**Docket No. A-2023-3043501**

Pennsylvania-American Water Company's Responses to the  
Bureau of Technical Utility Services Data Request Set 1

Application of Pennsylvania-American Water Company for the approval of  
the right to offer, render, furnish and supply water service to the public  
in a portion of Dimock Township, Susquehanna County

Pennsylvania-American Water Company  
 Susquehanna Operating Area  
 Proposed Service Territory Extension - Dimock Twp  
 923.33 Acres  
 Dimock, Susquehanna County

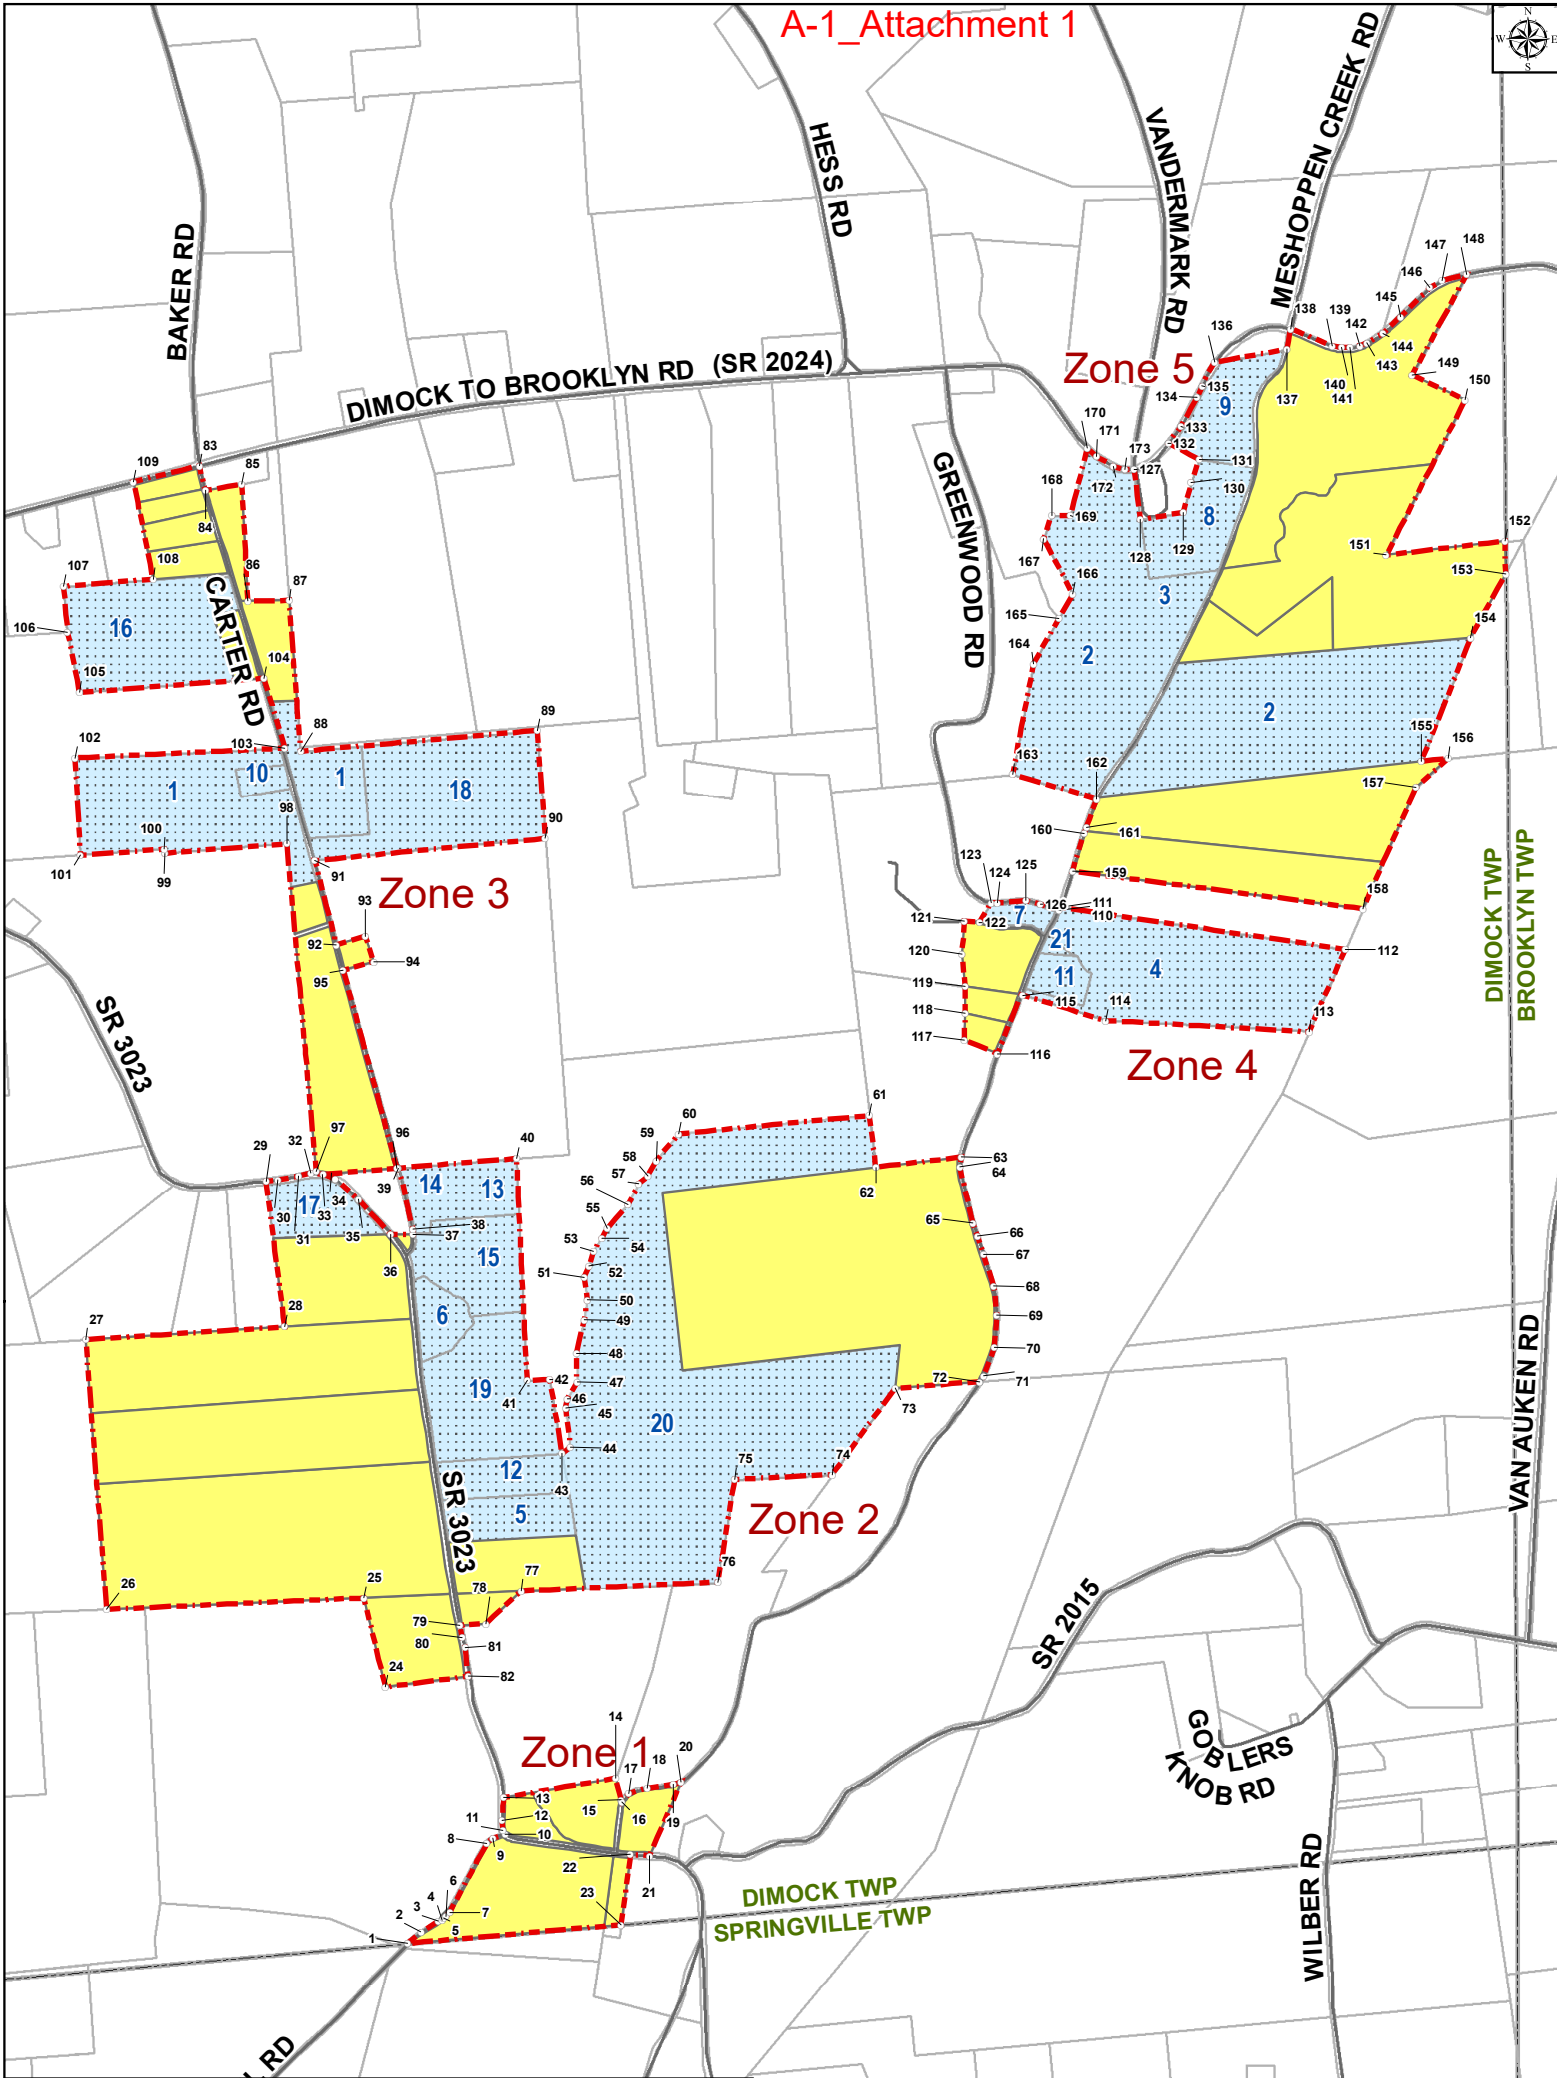
A-1. The Application's Exhibits E and F included a map and written description, respectively, of the requested service territory that used several roadway centerlines and intersections to define the requested territory's boundaries. However, roadway centerlines and intersections may shift or may be eliminated with future roadway expansion and realignment projects. Please provide revised Exhibits E and F to include a revised description of PAWC's requested service territory's boundaries using geographic coordinates for origin points and corresponding bearing angles and distances from each point. Also, please quantify the area of the revised requested service territory in acres of land.

A.2 The Application's Paragraph 20 and Exhibit A of the *pro forma* Offsite Development Marketing Agreement (ODMA) included in the Application's Exhibit D specified that proposed water facilities (the Water System) will include two wells. However, the map included with the ODMA's Exhibit A appears to depict the location of only one well. Please clarify the number of wells to be constructed as part of the Water System and provide a revised map depicting all well locations if there will be more than one well.

Response: The Exhibit E map has been revised utilizing geographic coordinates and corresponding bearing angles and distances from each point for the boundaries along the roadways. Please see A-1\_Attachment 1. The Exhibit F table description has also been revised corresponding to the changes made to the map in Exhibit E. Please see A-1\_Attachment 2. The total area (in acres) within the service territory boundaries has also been revised and is listed on both Exhibits E and F.

Response: The design and permitting of this project are still in the preliminary stages and the actual well locations have not been determined. The scope of the project is to provide two (2) supply wells (1 primary and 1 backup) and that both the primary well and the backup well will have sufficient production capacity to meet the demands of the system with only 1 well in operation. We are working on finding a site where we can drill both wells on the same parcel of land a short distance apart so that essentially, they are in the same location on a large-scale map, such as in Exhibit A. Based on this, the map provided in the application can, for the purposes of a preliminary representation, be the location of both wells for this project.
